AEROPRAKT SERVICE BULLETIN

№ SB A22LS-22

INCREASE OF WATER PUMP SCREW-CLAMP TORQUE OF A22LS AND A22L2 AIRCRAFT

Model: A22LS and A22L2

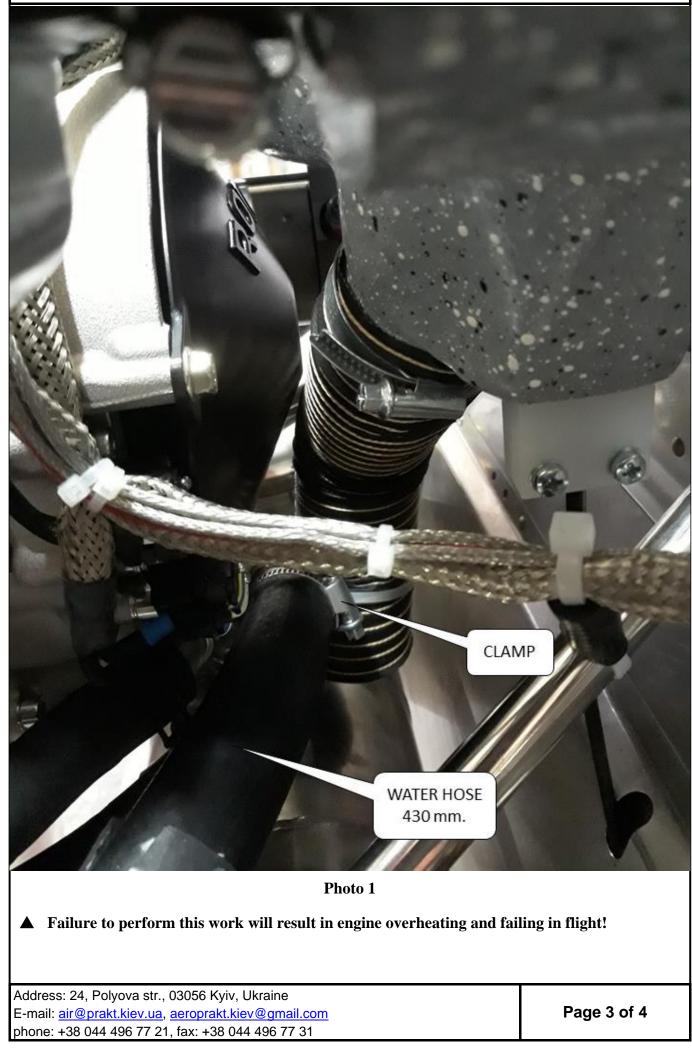
Due to change of the water hose properties by the hose manufacturer the water hose attached to the inlet of the water pump may disconnect in operation (see photo 1).

Screw-clamp attaching the water hose on the engine cooling system water pump inlet. See photo 1.

- 3.1) Remove the upper and lower cowling panels.
- 3.2) Tighten the screw-clamp shown in Photo 1 to $4 \text{ N} \cdot \text{m}$ (3 lb·ft) torque.
- 3.3) Put back the upper and lower cowling panels.
